<b>Docket Number:</b>	24-OPT-03
<b>Project Title:</b>	Soda Mountain Solar
<b>TN #:</b>	265841
<b>Document Title:</b>	Basin and Range Watch Comments - Please Select a No Project Alternative for Soda Mountain Solar
<b>Description:</b>	N/A
<b>Filer:</b>	System
<b>Organization:</b>	Basin and Range Watch
<b>Submitter Role:</b>	Public
<b>Submission Date:</b>	9/1/2025 1:47:38 PM
<b>Docketed Date:</b>	9/2/2025

**Please Select a No Project Alternative for Soda Mountain Solar**

**re: Comments on Notice of Preparation of a Draft Environmental Impact Report for the Soda Mountain Solar Project**

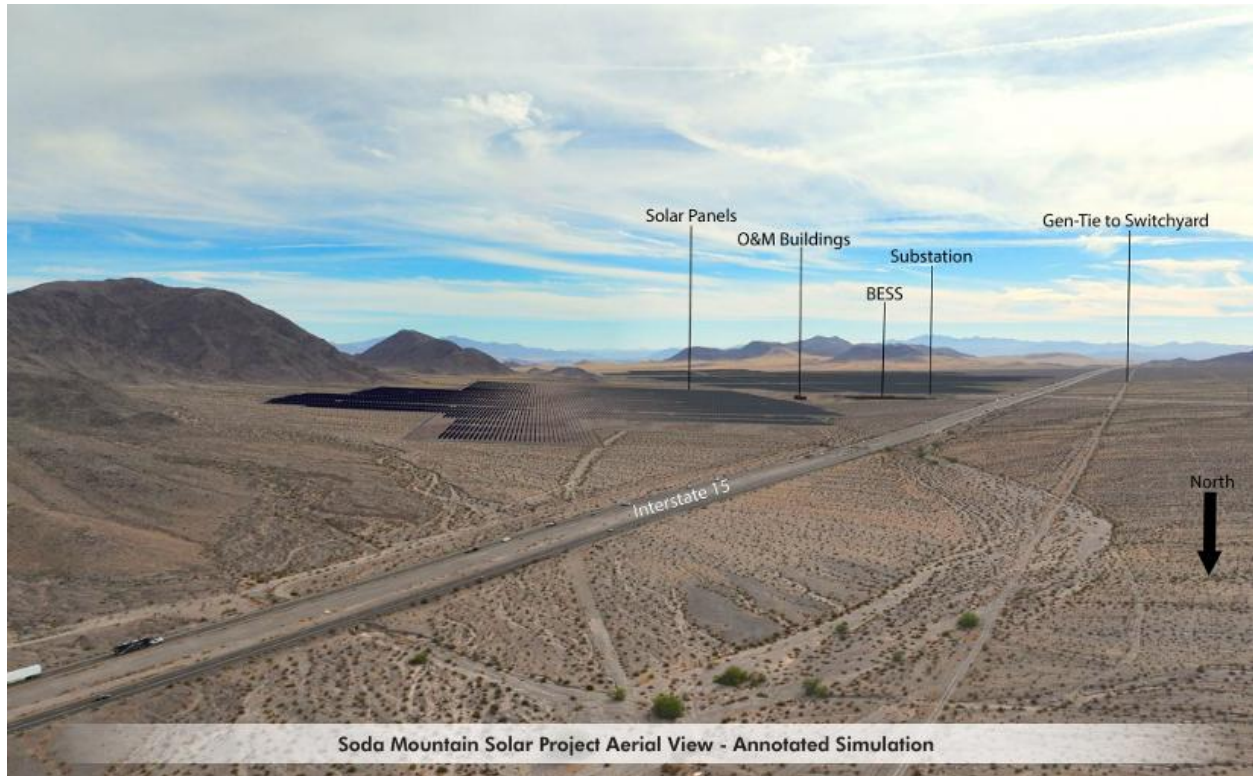
The visual KOP simulations by SWCA are better than their past efforts for other projects but should also show simulations from higher elevations in the Mojave National Preserve. The

photo below shows the project footprint but does not show the full impacts and the panels are simulated fading away due to axis tracking. This would be a much stronger contrast and should be emphasized more. This simulation has been designed to undermine the full visual impact.
